UNITED STATES OF AMERICA
NUCLEAR REGULATORY COMMISSION

In the Matter of)
DAIRYLAND POWER COOPERATIVE)
(La Crosse Boiling Water Reactor))

) Docket No. 50-409
) Amendment to
) Provisional Operating
) License No. DPR-45

APPLICANT'S RESPONSE TO
CREC'S FIRST SET OF
INTERROGATORIES DATED SEPTEMBER 18, 1978

SPENT FUEL POOL COOLANT SYSTEM

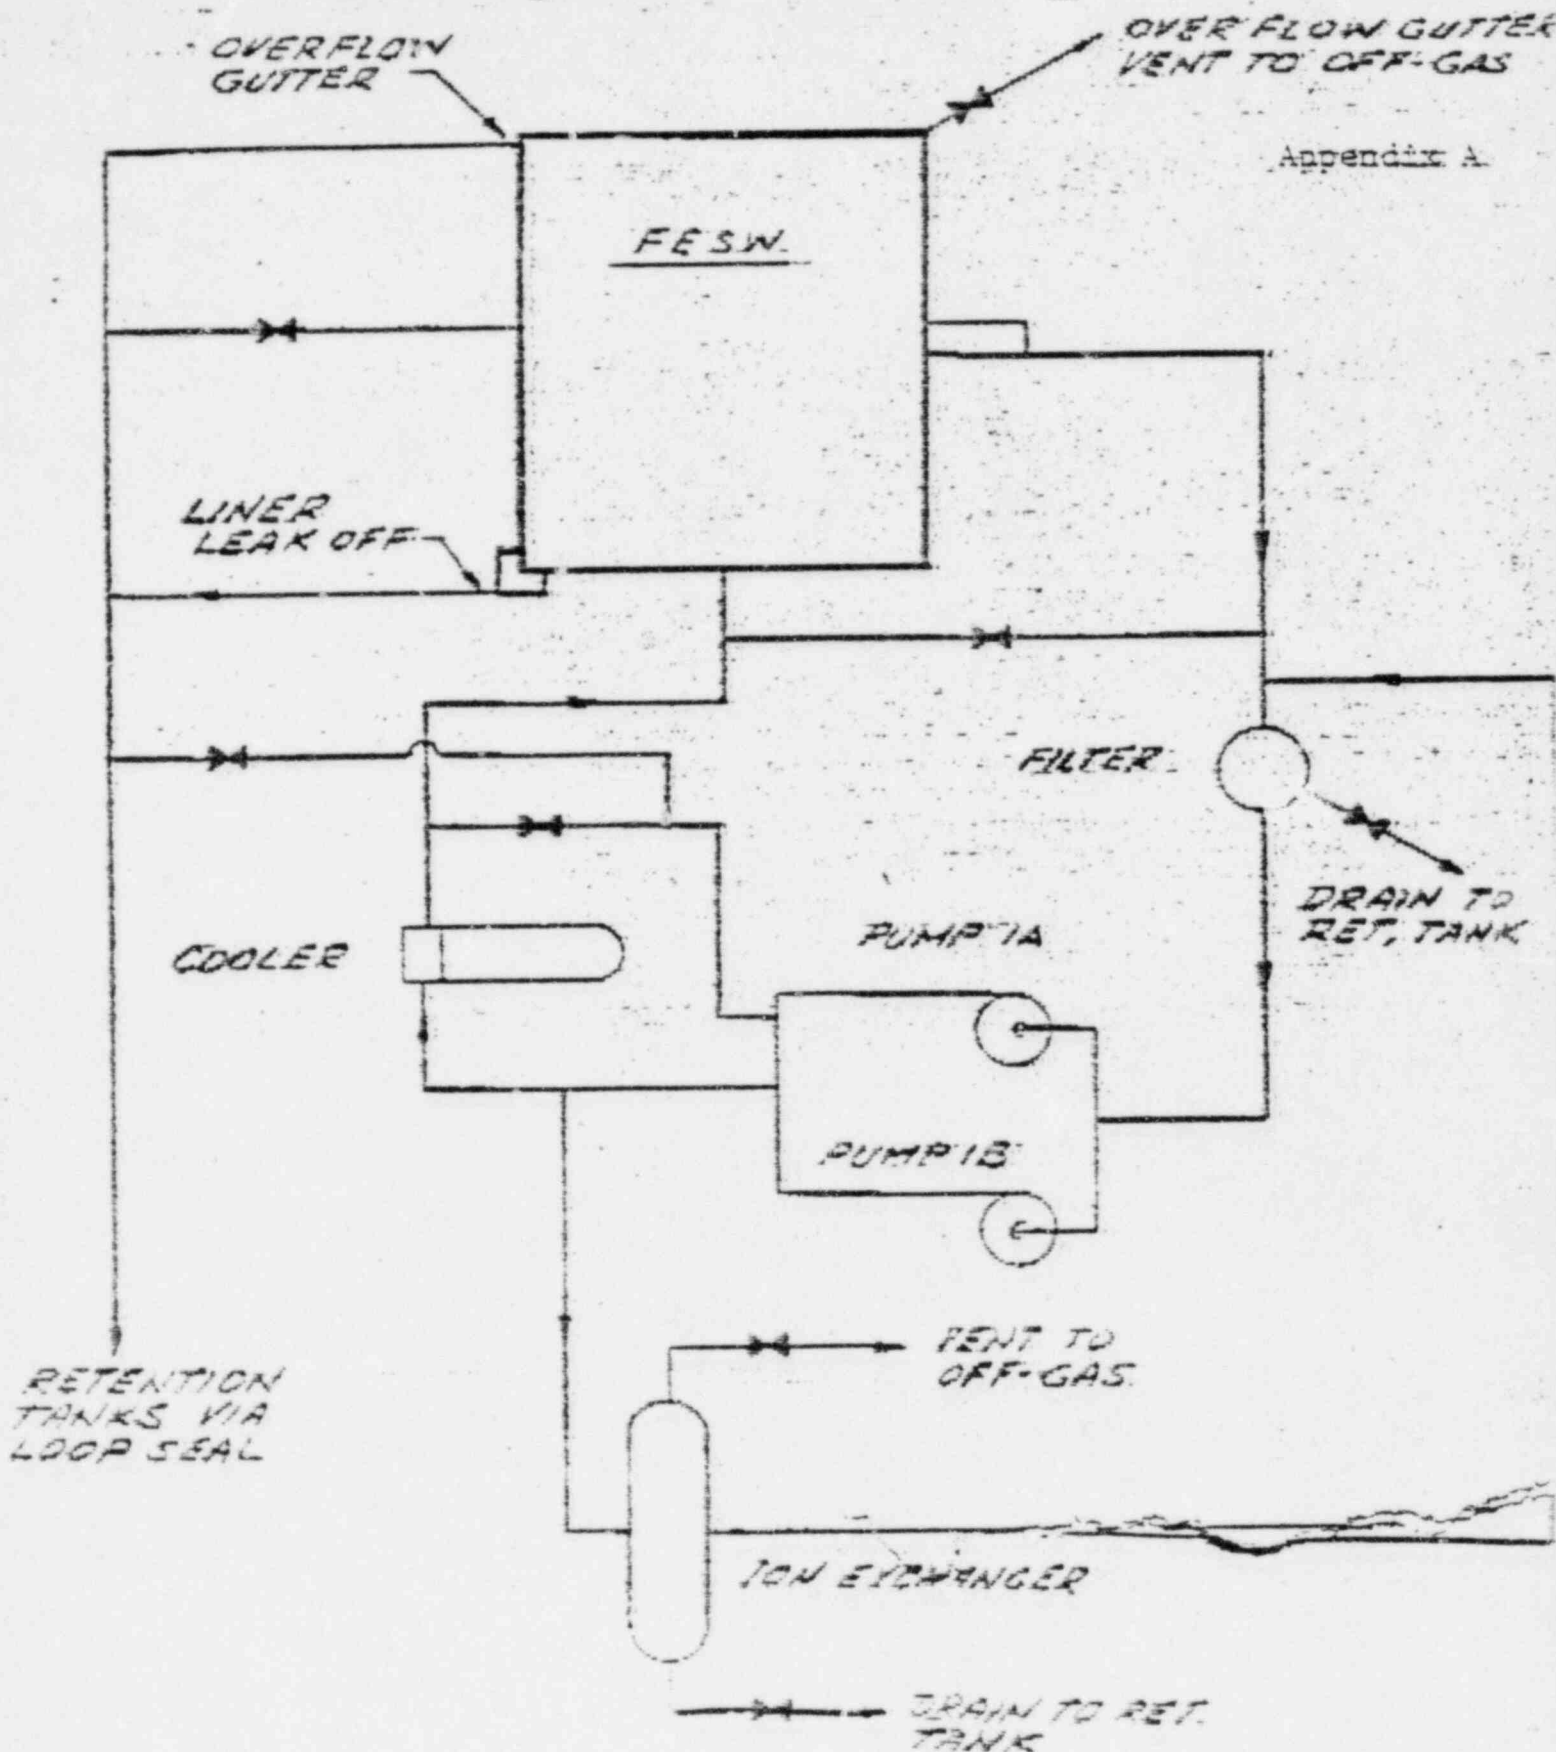
Interrogatory No. 15

System and the interconnections, if any, to the plant radioactive treatment system.

See Appendix A hereto.
